CERTIFICATE OF APPROPRIATENESS

Property: 4009 Pineridge Street, Lot 13, Block 125, North Norhill Subdivision. The property includes a historic 916 square foot, one-story wood frame single-family residence and historic one-story detached garage situated on a 5,000 square foot (50' x 100') interior lot.

Proposal: Alteration – Revision. Construct an approximately 900 square foot one-story rear addition. The addition will begin at the existing rear wall, have a ridge height lower than existing, and will be clearly delineated from the historic structure.

Effective: March 26, 2015

**WEST (REAR) ELEVATION**

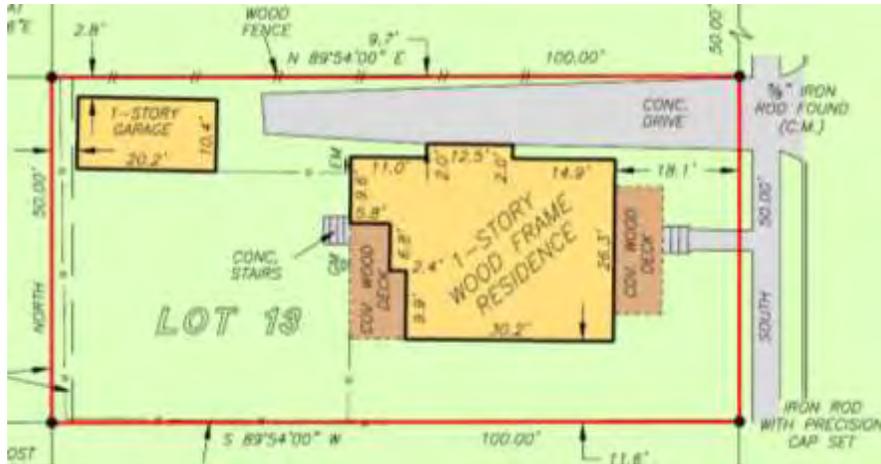
- Remove two (3X5) windows from the Northern Wall of addition
Install two windows on the west (rear) elevation of the addition, flanking the door
Remove ribbon window from the south elevation of addition.
Raise ribbon window on the south elevation of the addition
Change double windows on the south elevation of the addition to a single ribbon window
Add window on east elevation of addition.
Move location of addition 1'-6" to the south to ensure room for a single car garage as previous site plan was incorrect
Removed shiplap siding from interior of historic home and reframed to meet current code; requests approval to add wall covering replacement material: 4'x12' sheets of 5/8" sheetrock.

Incorrect Site Plan (Submitted 12/17/2017)

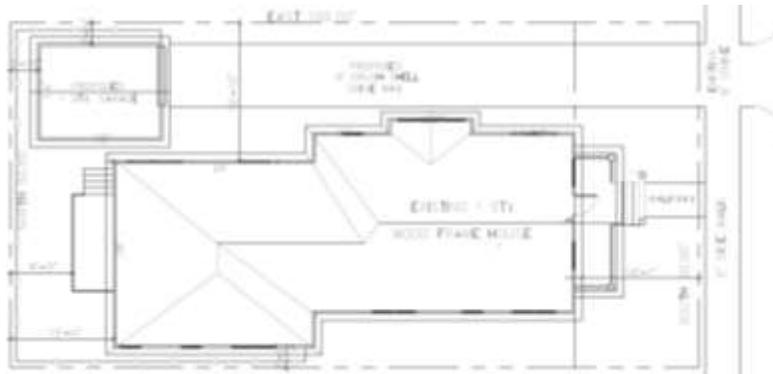
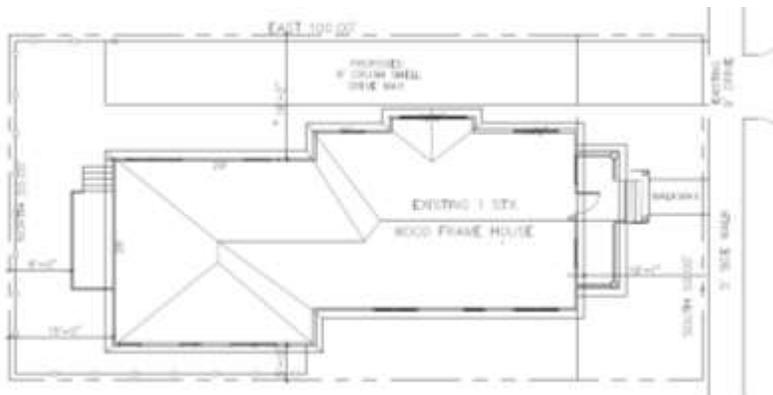
Corrected Site Plan

FIRST FLOOR PLAN

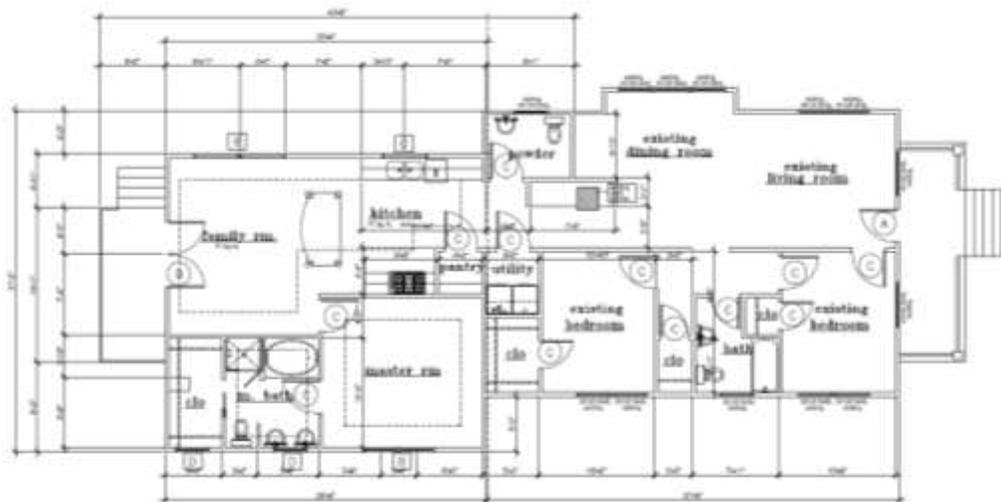
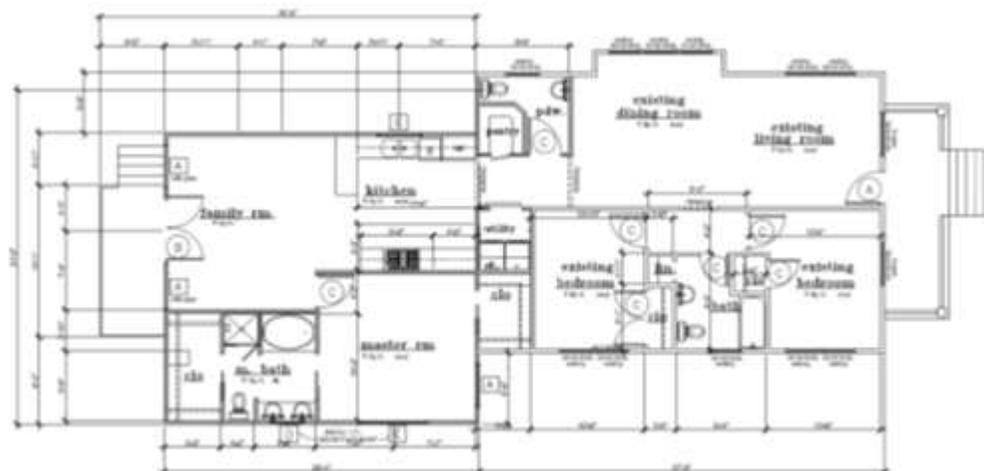
*Proposed 03/26/2015:*

In the revised proposal the addition will be shifted 1'-6" to the south. The addition will extend 6'-8" out to the south and will be inset 5'-6" on the north. The addition will extend 29'-4" towards the rear. The proposed addition will have a ridge height of 19'-0". See drawings for more detail.
